January 23, 2023

Re: Supplemental Hydrogeologic Review
Proposed 11 Lot Subdivision
Putnam River Road, LLC & 285 River Road, LLC

POND No. 1 SOILS MAP
PREPARED FOR
**PUTNAM RIVER ROAD L.L.C. &
285 RIVER ROAD, LLC**
RIVER ROAD & MODOCK ROAD
PUTNAM, CONNECTICUT

**Groundwater Elevations Measured at Monitoring Wells
in the Stratified Drift Aquifer**

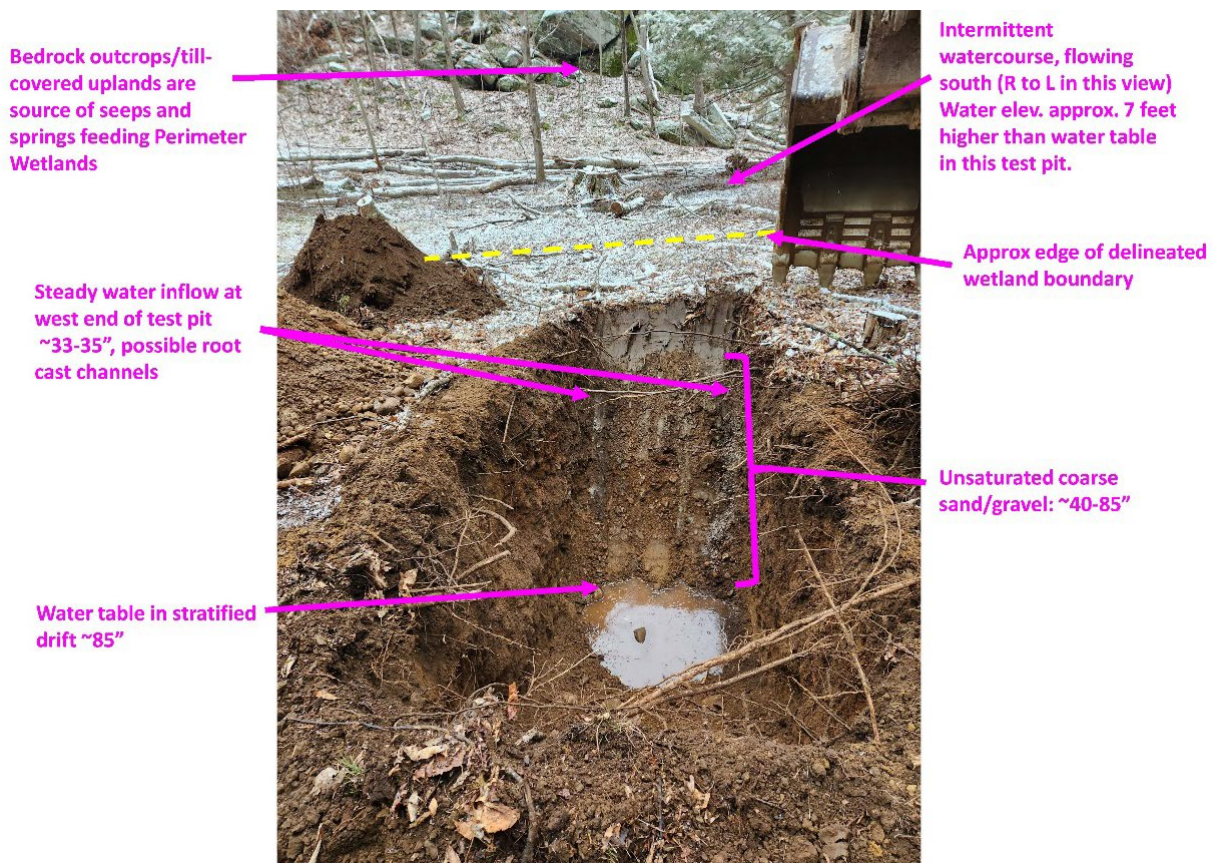
Note the very small rise in groundwater levels in all three wells between December 30 and January, 20 despite several periods of heavy rainfall and total rainfall throughout this period of more than 3.9 inches. This information is consistent with the hydrogeologic conditions of highly permeable stratified drift discharging readily to the wetlands to the northeast, along Carpenter Brook. Under these conditions, it is likely not possible under any meteorological conditions to saturate the stratified drift soils all the way up to the base of the perched zone of the Perimeter Wetlands.

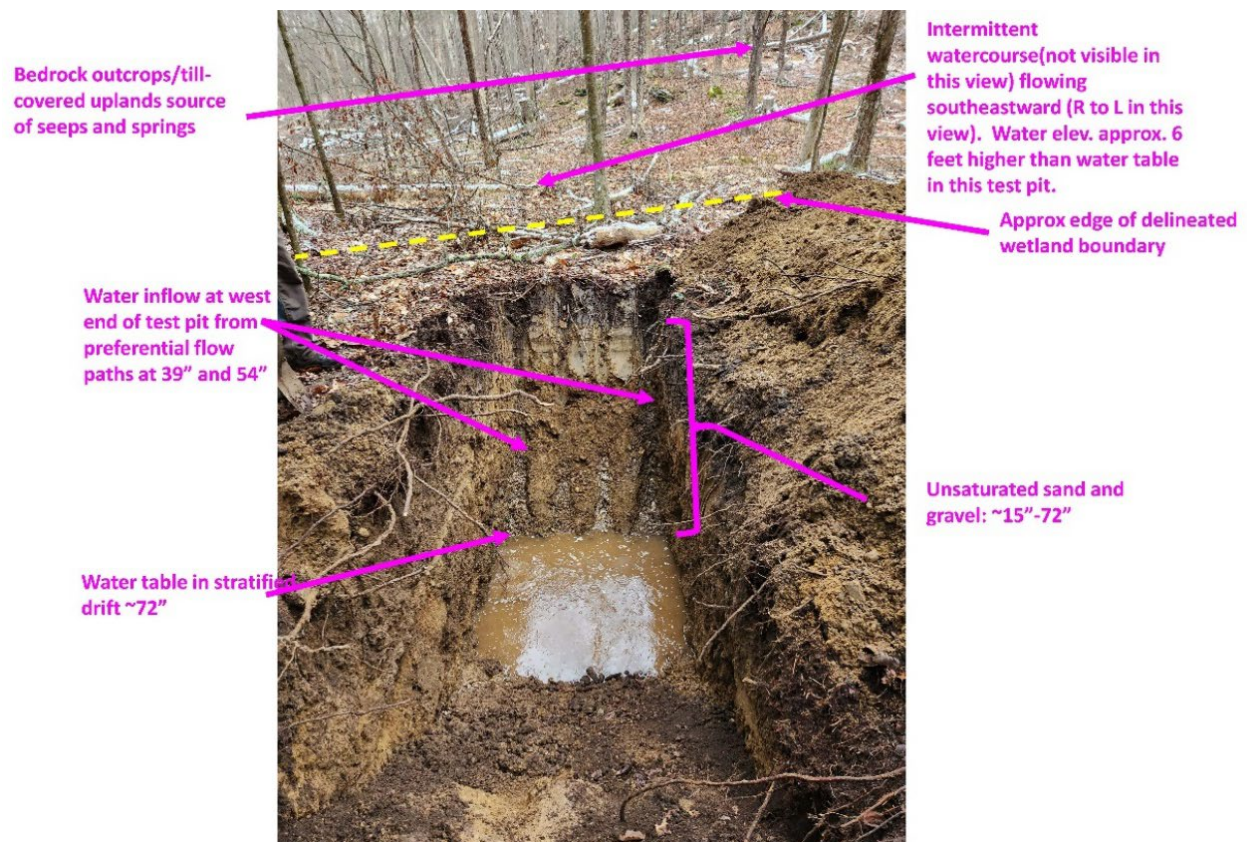
Test Pit TP-A. The water table here is about 85 inches deep, or about 7 feet below the level of water in the intermittent watercourse. The sands and gravels are highly permeable, indicating very little hydraulic gradient and confirming that the surface water exists in a perched zone that is isolated from the underlying stratified drift aquifer. Although the soils above the water table are unsaturated, steady horizontal flow through preferential flow paths at about 33-35 inches deep was contributing water to the hole in a steady trickle.

Test Pit TP-A. Note the glistening vertical streak at the right corner of the hole, marking the steady trickle of water flowing down over the unsaturated sand and gravel. This water entered the test pit at a depth of 35 inches along a preferential flow path. A smaller trickle of water flowed into the far left corner of the hole. The test pit was kept open for 15 minutes and the inflows continued without sign of decreasing. Preferential flow paths along the margins of perched areas are commonly caused by the presence of cemented root casts of decayed tree roots. These root cast channels and other layers or stringers of more permeable sands can intersect and form a network that drains water horizontally away from the saturated areas of the perched water zone. At some distance from the perched zone, this flow becomes a trickle and then disappears entirely, as the water will have soaked into the surrounding, unsaturated sediments or drained to the water table. Note that the inflows of shallow water along preferential flow paths occurred only on the end of TP-A nearest the wetland, indicating that the source of the water was the saturated soils and intermittent watercourse of the Perimeter Wetlands.

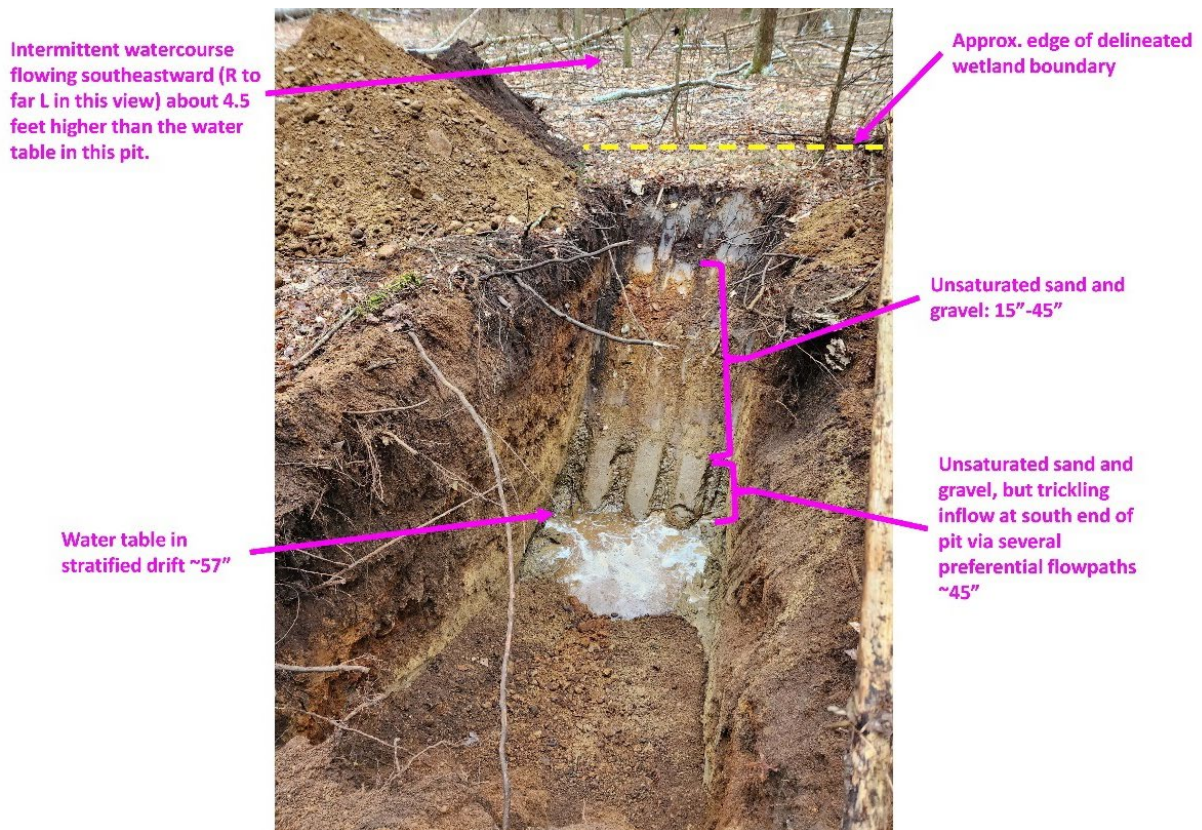
Test Pit TP-B. The water table in this test pit was about 72 inches deep, or about 5.5 feet below the level of water in the nearby intermittent watercourse. As in TP-A, the sands and gravels were unsaturated above the water table, but preferential flow paths at the end of the test pit nearest the wetland steadily discharged water into the hole at depths of 39 and 54 inches, well above the water table.
